JUSTIFICATION

REMOVAL OF INTERNAL CASEMENT WINDOWS

107 HIGH STREET, LINDFIELD, HAYWARDS HEATH, RH16 2HR

3. Approved first floor plan - submitted drawings under application DM/22/3694 & DM/22/3695 (planning approved)

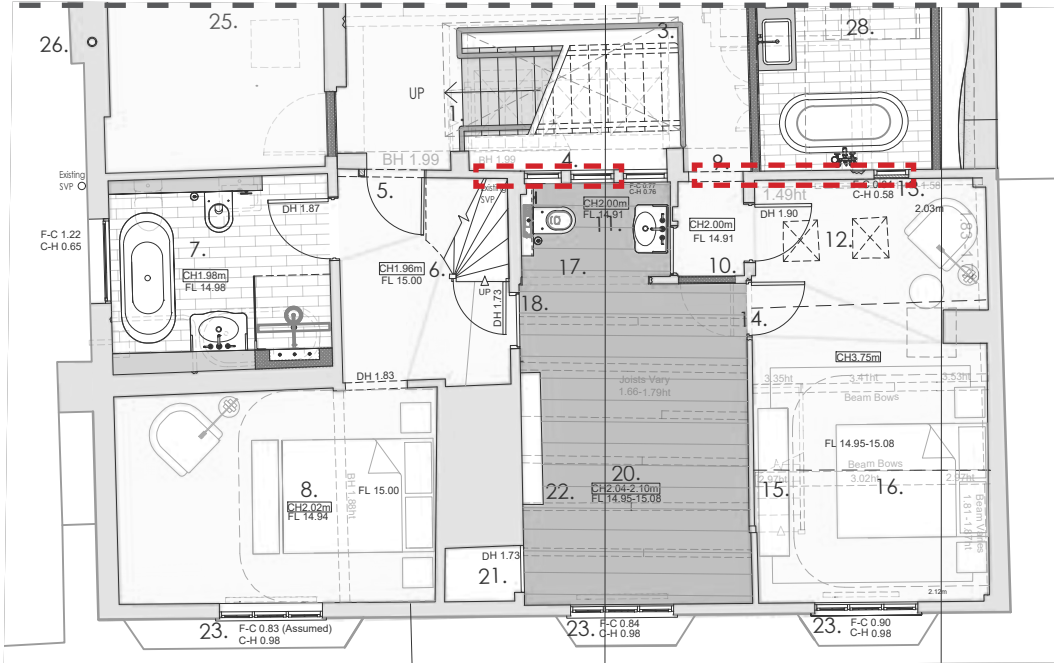
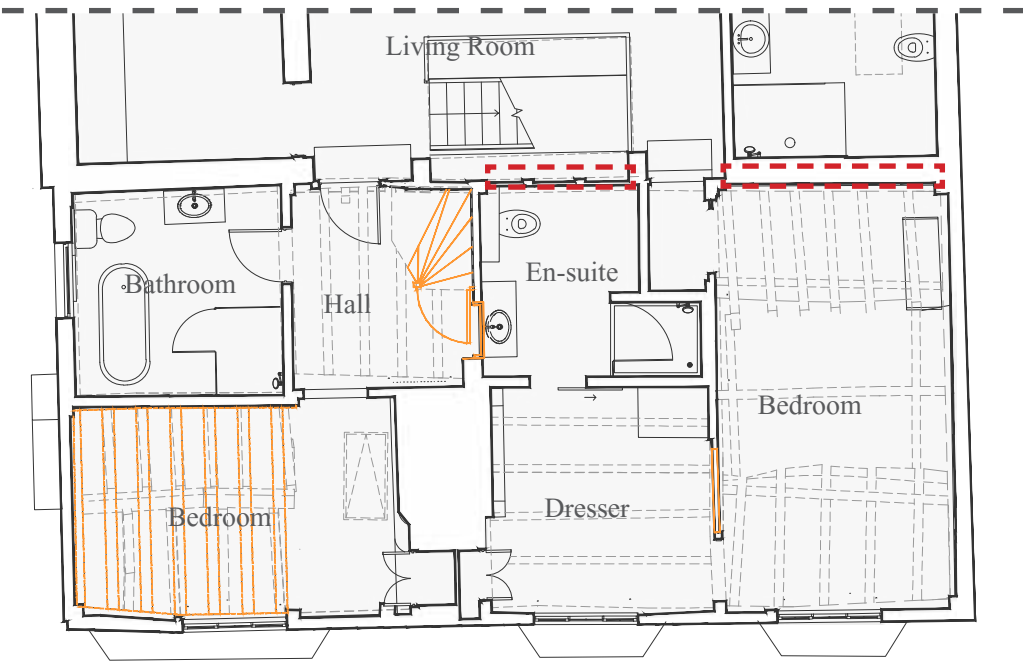
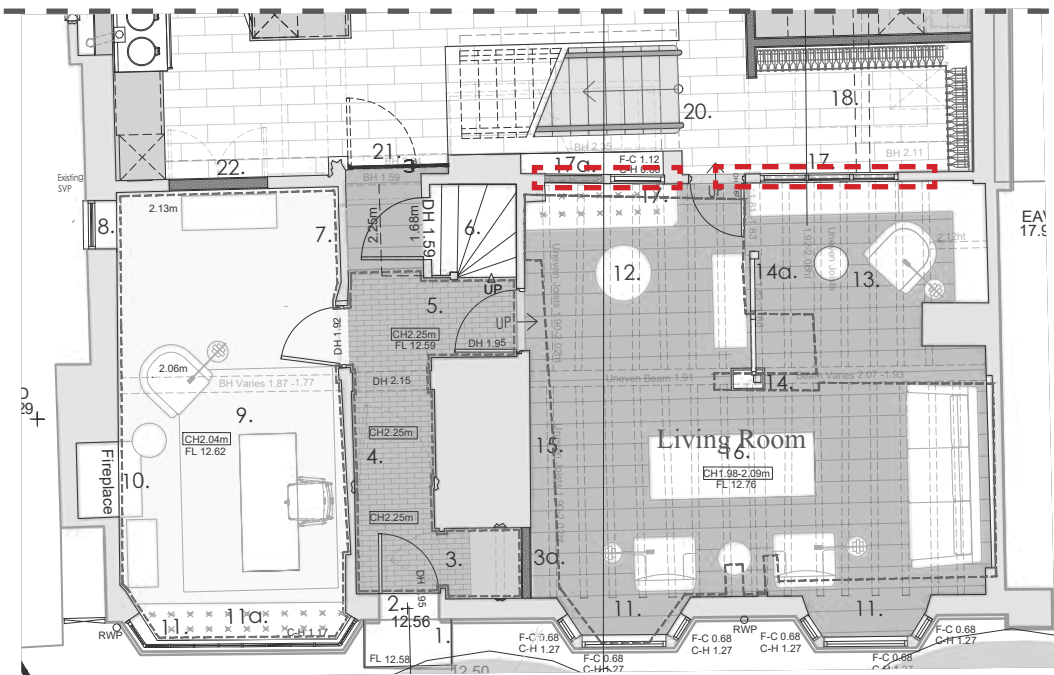
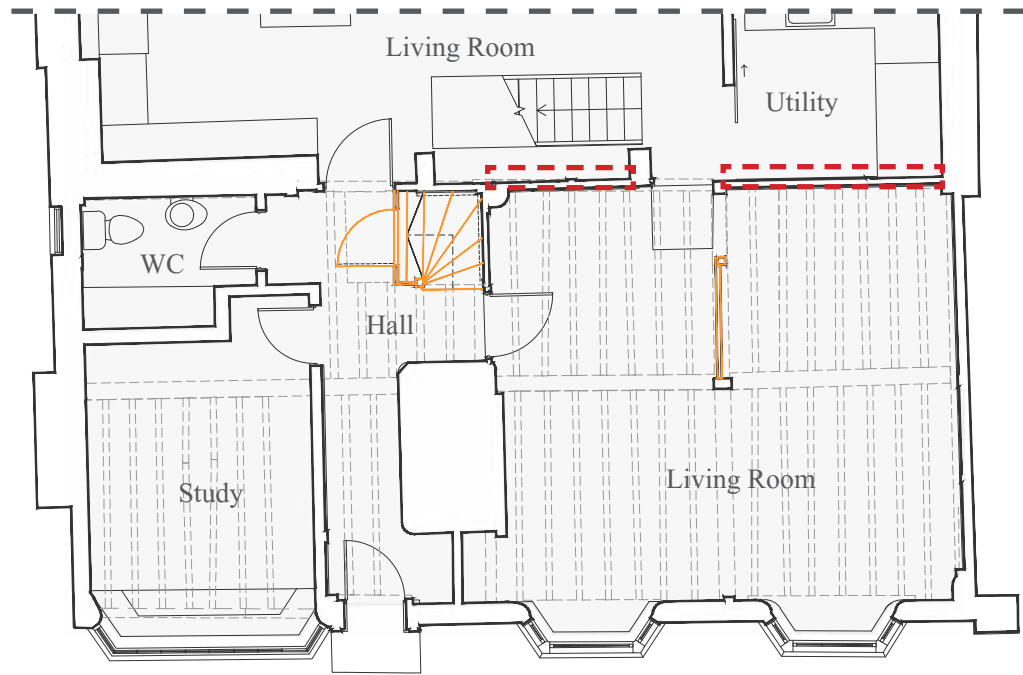
The casement windows to the west facade of the listed building have been removed and openings filled in, deviating from the approved scheme proposing their retention.

The windows were not original, added in 1990s and poorly detailed. After their removal the openings have been infilled with traditional fibrous wood wool boards faced in lime plaster. This change reveals and expressed the 15th century timber framing, which has been carefully repaired and renovated, which according to the supporting HCUK report is a significant heritage benefit.

Drawing GH342 PL02 Rev B approved drawings under application DM/22/3694 & DM/22/3695

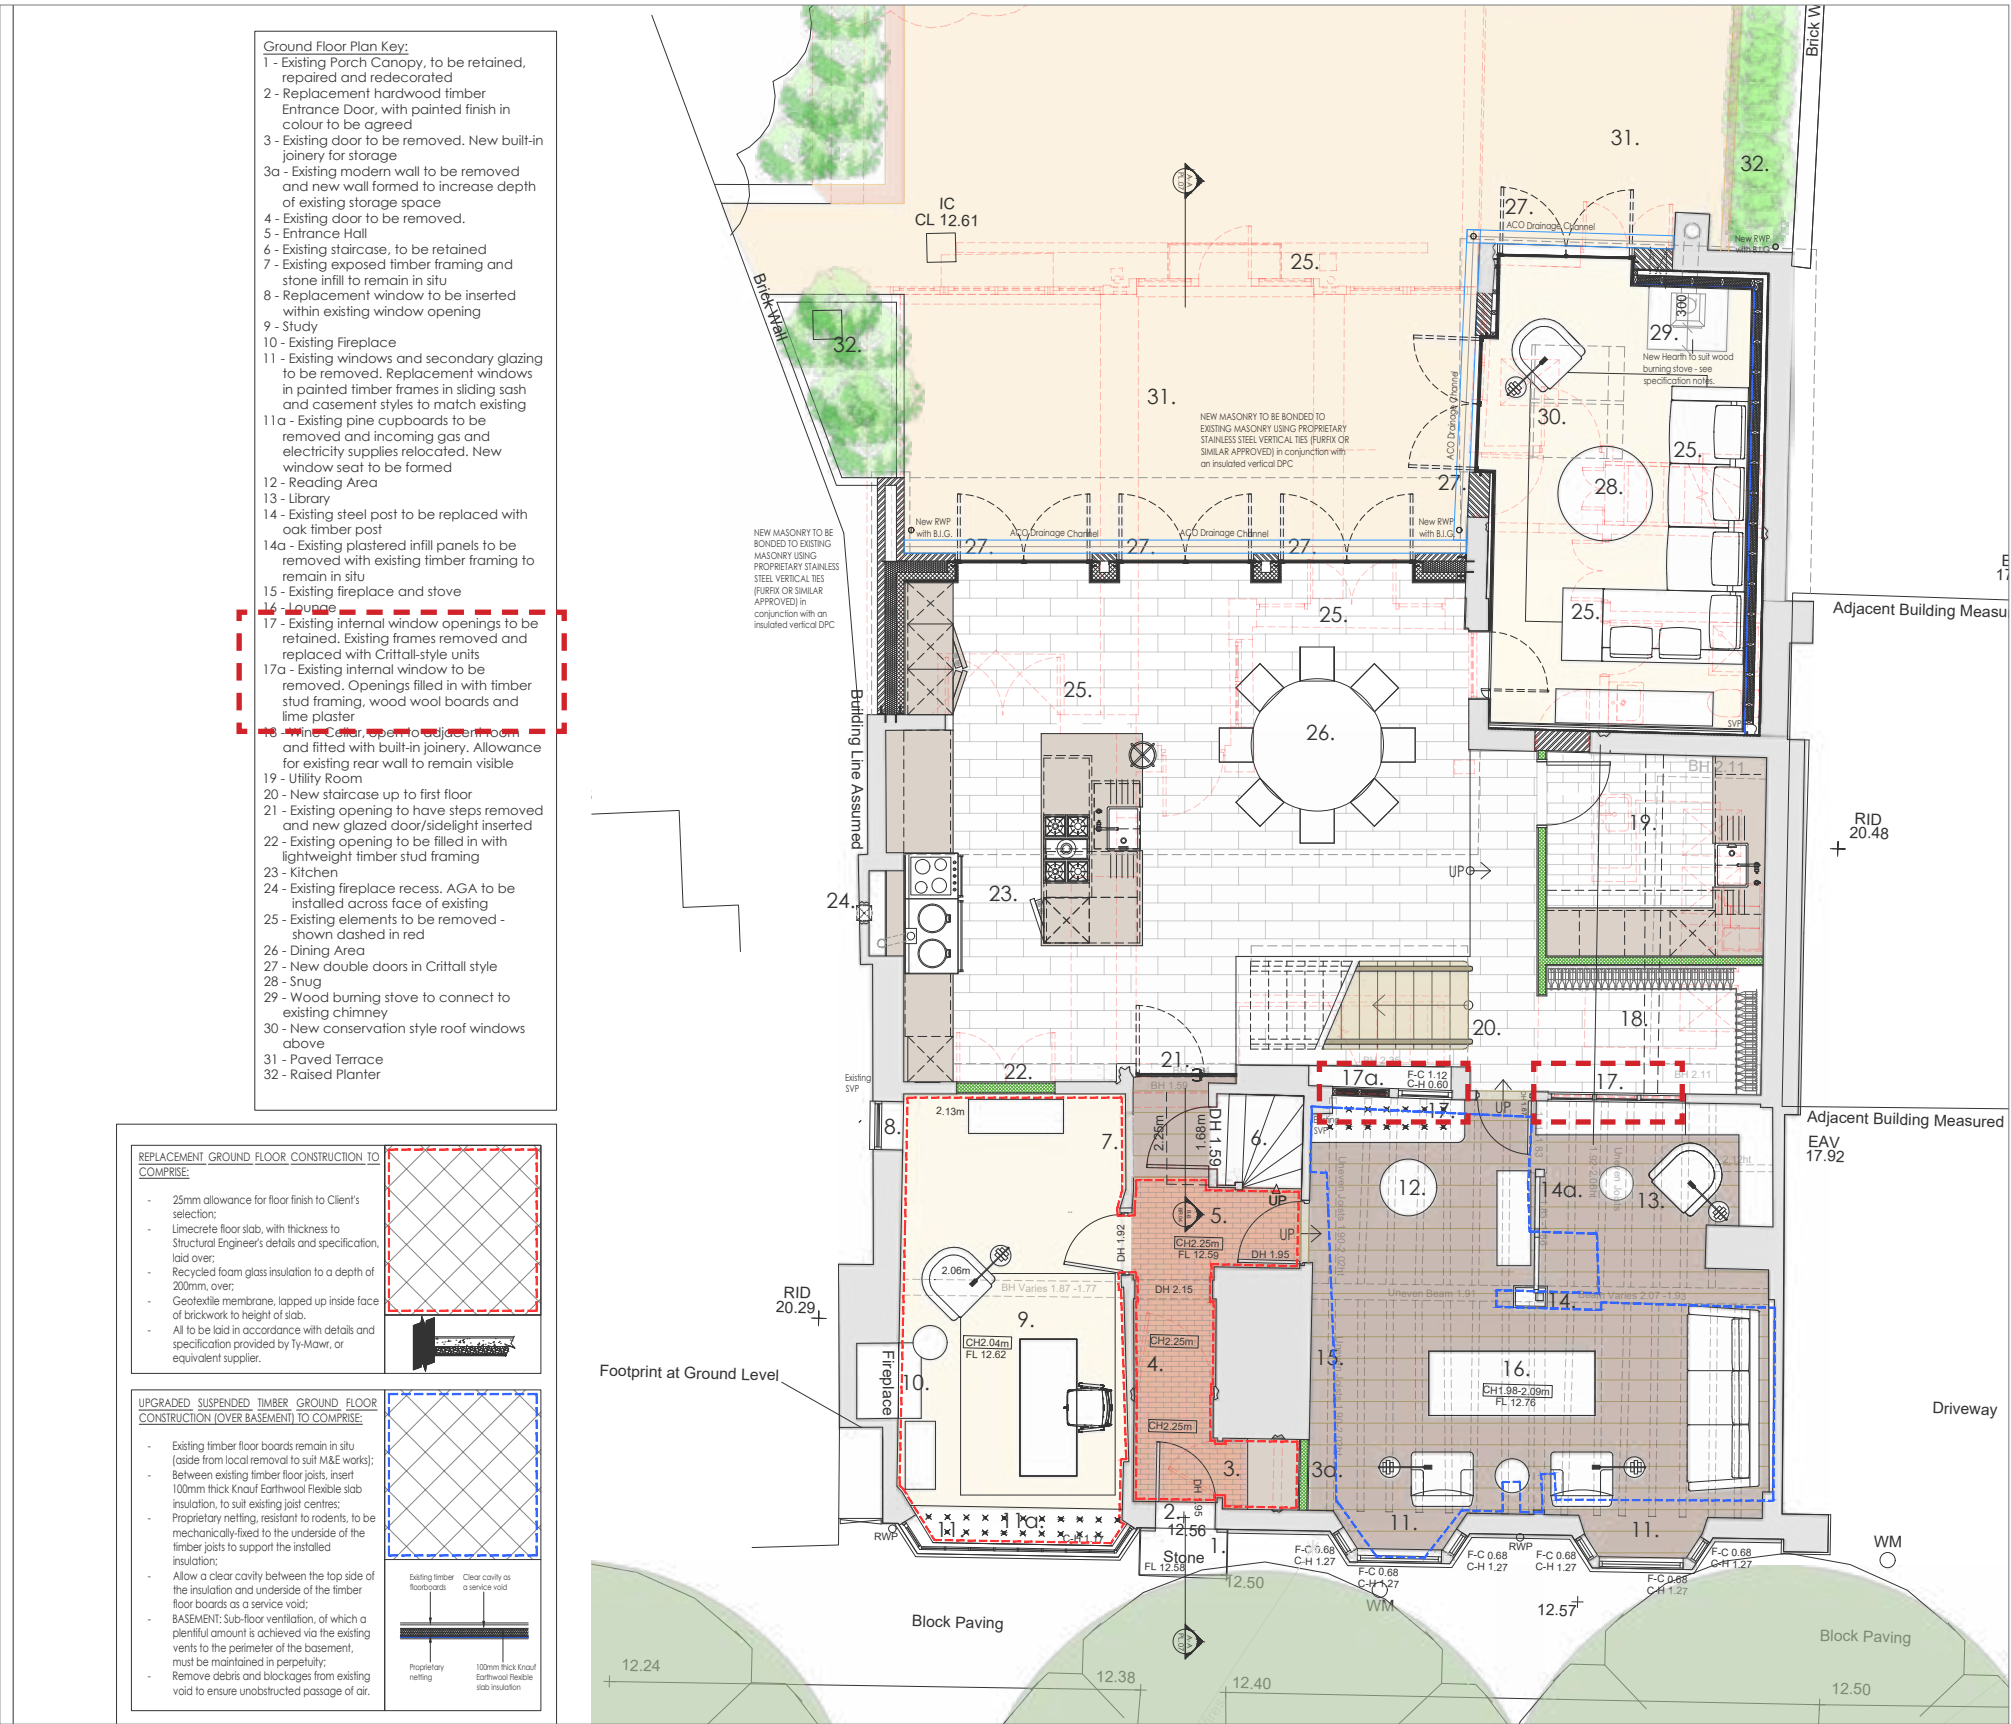
Point 17 of the approved drawing GH342 PL02 Rev B confirms removal of existing casement windows.

Point 17a, relating to the internal opening adjacent to the corkscrew staircase, confirms filling in of the opening with timber stud framing, wood wool boards and lime plaster.

‘17 - Existing internal window openings to be retained. Existing frames removed and replaced with Crittall-style units
17a - Existing internal window to be removed. Openings filled in with timber stud framing, wood wool boards and lime plaster.’

Drawing GH342 PL03 Rev C approved drawings under application DM/22/3694 & DM/22/3695

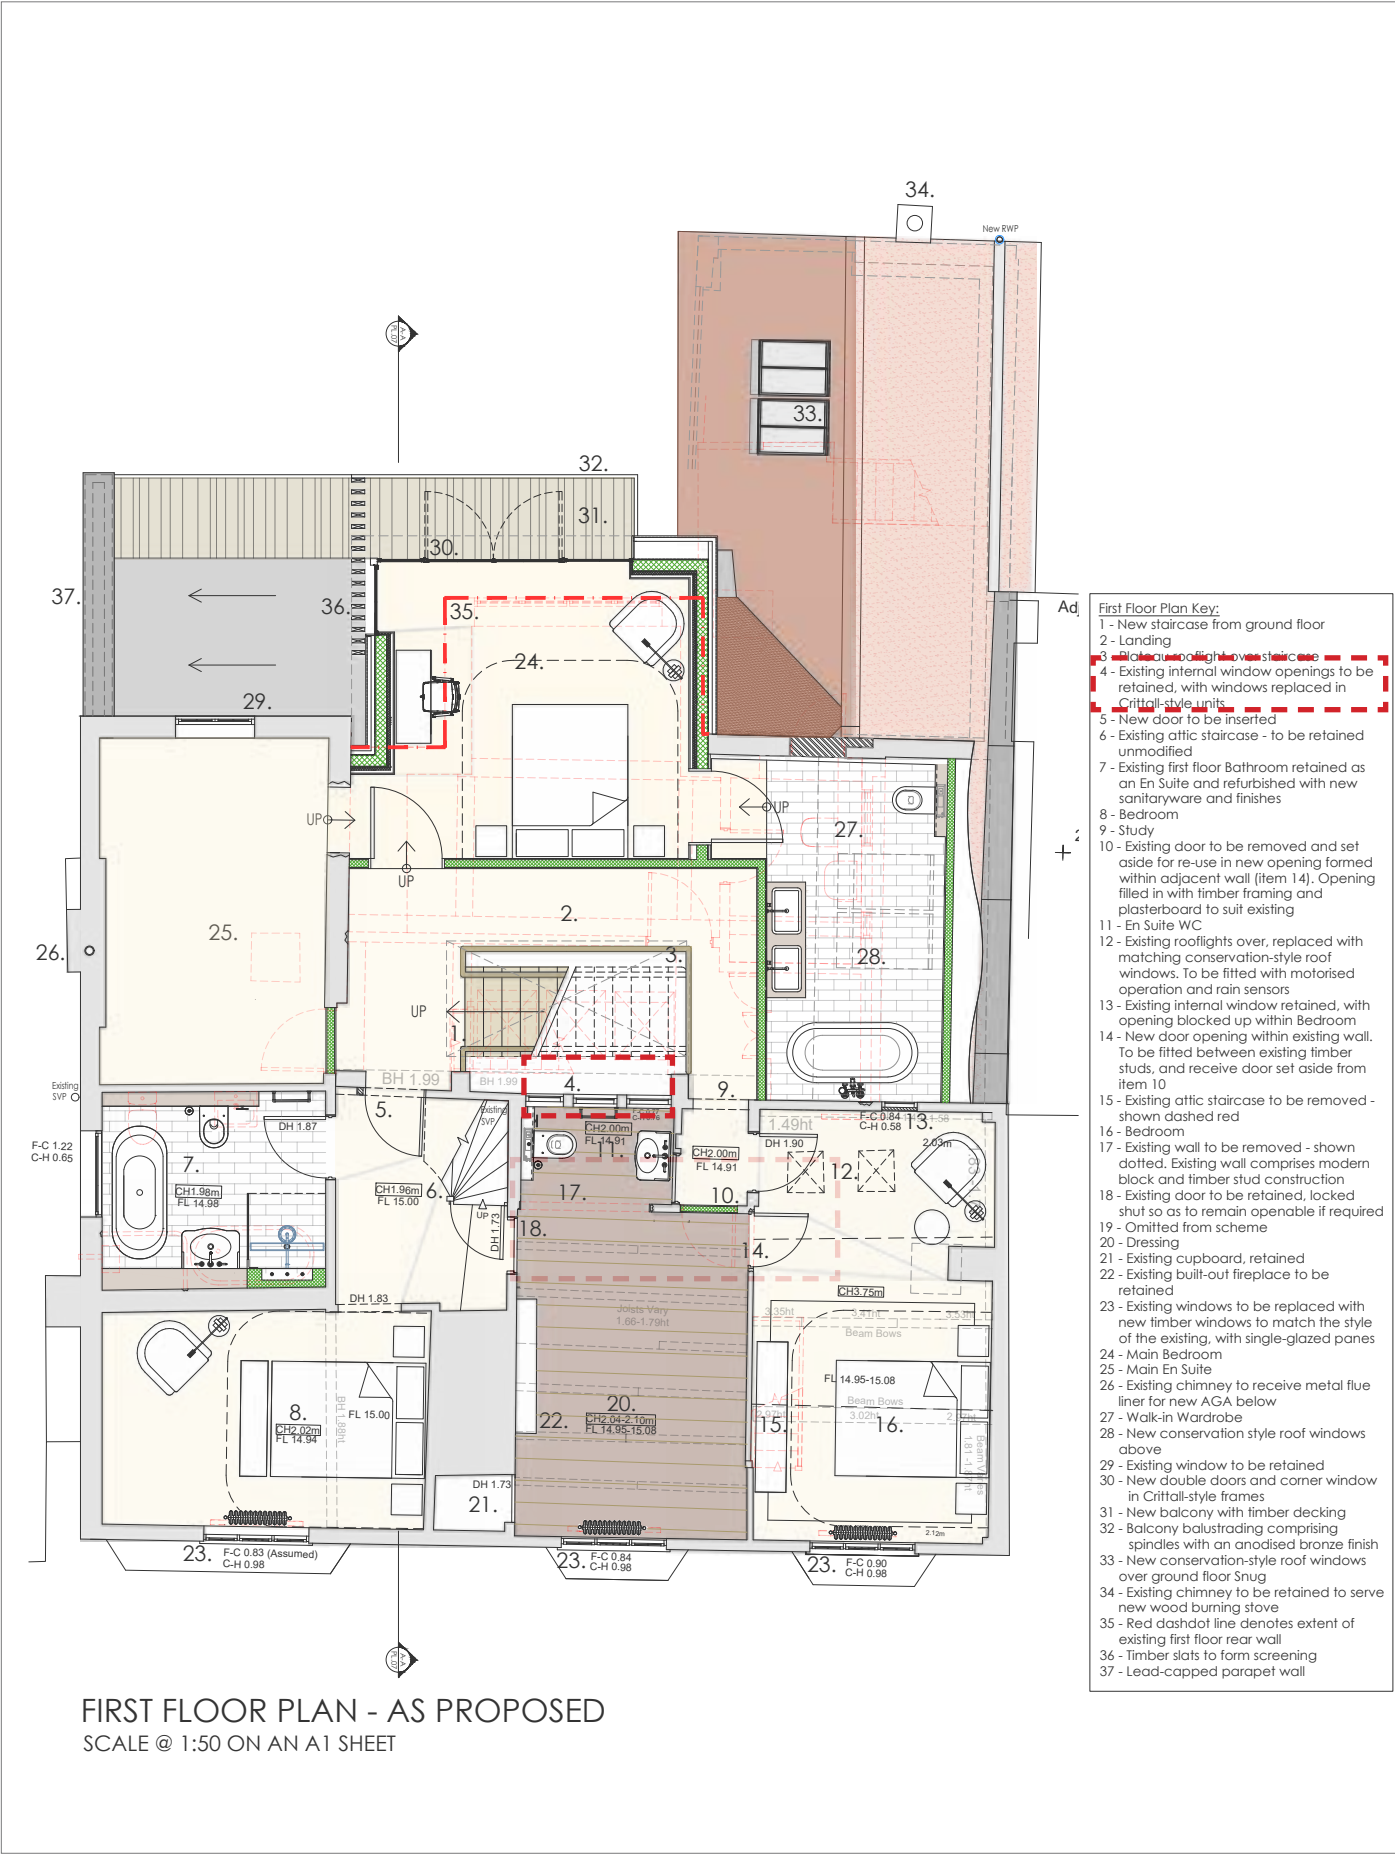
Point 4 of approved drawing GH342 PL03 Rev C confirms removal of existing windows and replacement with crittall-style units. This has been partially implemented by removal of windows. The openings were blocked up with wood wool and lime plaster, which was a more in-keeping solution.

‘4 - Existing internal window openings to be retained, with windows replaced in Crittall-style units’

1. Approved first floor plan - submitted drawings under application DM/22/3694 & DM/22/3695 (planning approved)

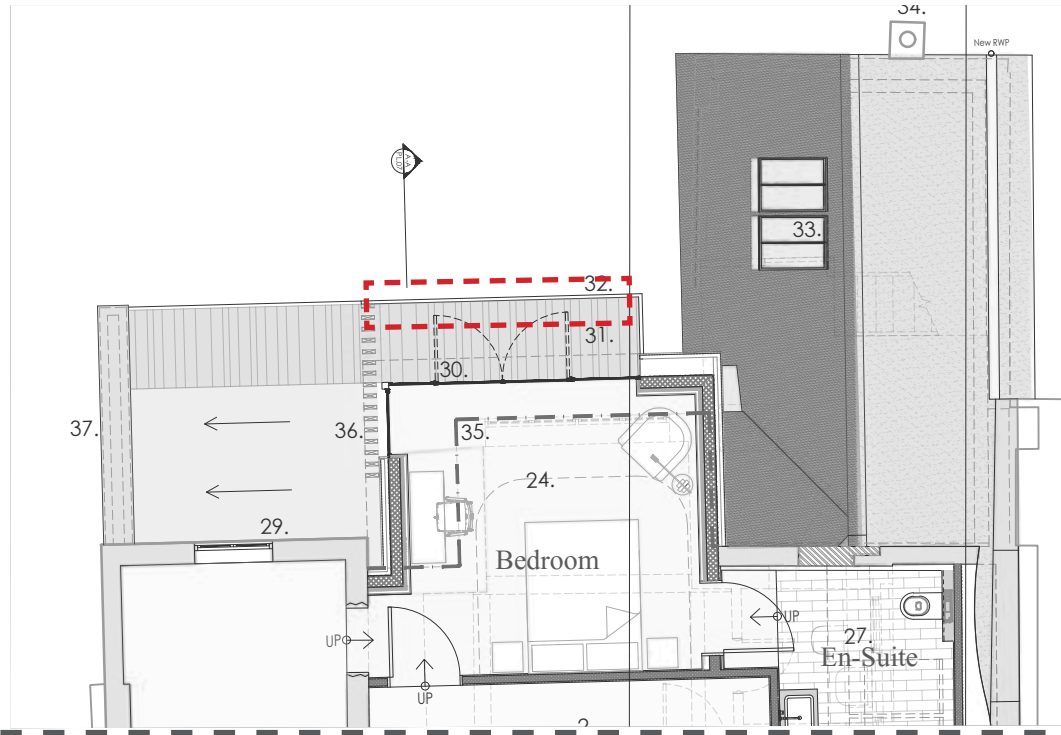
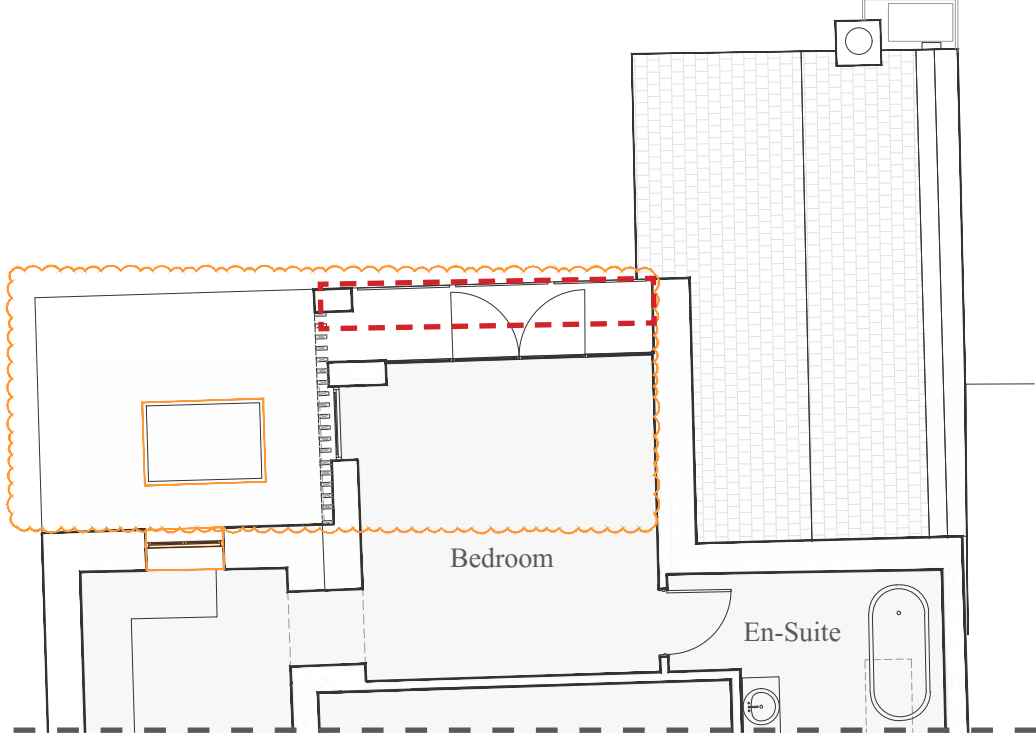
The balustrade to rear terrace has been constructed in deviation to the approved scheme. Due to the increased width of the ‘as-built’ extension the current balustrade has more length. It is proposed that the rear extension will be reconstructed to be in general accordance with the approved scheme, theretofore the length of the balustrade will be closer to what was approved. Its design has been changed from metal rail with balusters to a frameless glazing system.

The change to a frameless glazing system is more discreet and visually seamless, reducing the visual obstruction of the overall appearance of the facade, creating less distraction and visual clutter. According to the supporting HCUK Heritage Statement, it is considered to have neutral impact on the significance of the listed building.
